# Access Compliance Report

## Public Rights-of-Way

Intersection ID: N/A	Main Street: CALDWELL_RD	Cross Street: OLD_STONE_CROSSING_DR	Location: SW
ADA ID: 4034899042EE	Ramp Type: Combination1Diag	Initial Pass/Fail: Fail	Overall Compliance: No
		Severity Score: 0

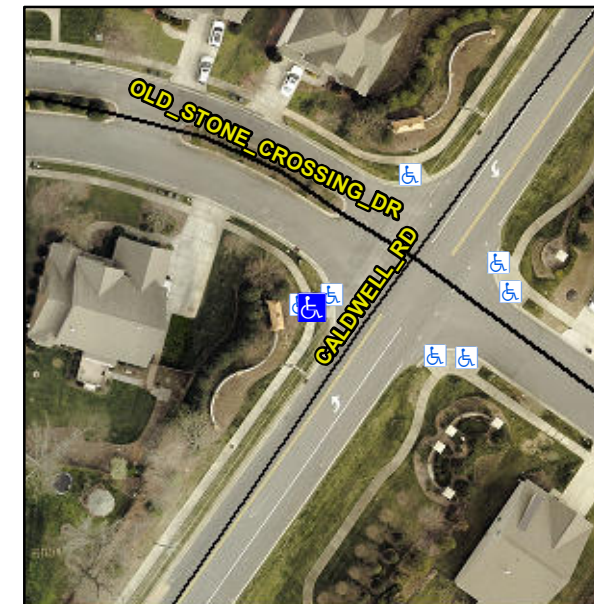
**Not Found, R304.5.1, R304.5.3, R304.3.2**

Compliance	Description	Data	Compliance	Description	Data
N/A	Ramp Length LT (in)	40.0	N/A	Ramp Length RT (in)	26.5
Yes	Ramp Width LT (in)	58.0	Yes	Ramp Width RT (in)	62.0
Yes	Ramp Slope LT (%)	6.8	No	Ramp Slope RT (%)	8.6
No	Ramp XSlope LT (%)	3.8	Yes	Ramp XSlope RT (%)	1.7
N/A	Ramp Length (in)	92.0	Yes	Ramp Slope (%)	5.0
No	Ramp Width (in)	46.0	No	Ramp XSlope (%)	6.6
N/A	Flare Type LT	N/A	N/A	Flare Type RT	N/A
N/A	Flare Slope LT (%)	N/A	N/A	Flare Slope RT (%)	N/A
N/A	Flare Traversable LT?	N/A	N/A	Flare Traversable RT?	N/A
N/A	Landing Length (in)	N/A	N/A	DWS Provided?	N/A
N/A	Landing Width (in)	N/A	N/A	DWS Contrast?	N/A
N/A	Landing Slope (%)	N/A	N/A	DWS Length (in)	N/A
N/A	Landing X Slope (%)	N/A	N/A	DWS Full Width?	N/A
N/A	Landing Curb? (Y/N)	N/A	N/A	DWS Offset (in)	N/A
N/A	Shared Landing?	N/A			
N/A	Gutter Ponding?	N/A	N/A	Gutter Slope (%)	N/A
N/A	Gutter Lip Ht (in)	N/A	N/A	Gutter X Slope (%)	N/A
N/A	Painted X Walk1?	No	N/A	Painted X Walk2?	No

**Remove & Replace Curb Ramp With Two New Directional Ramps or Equivalent.**
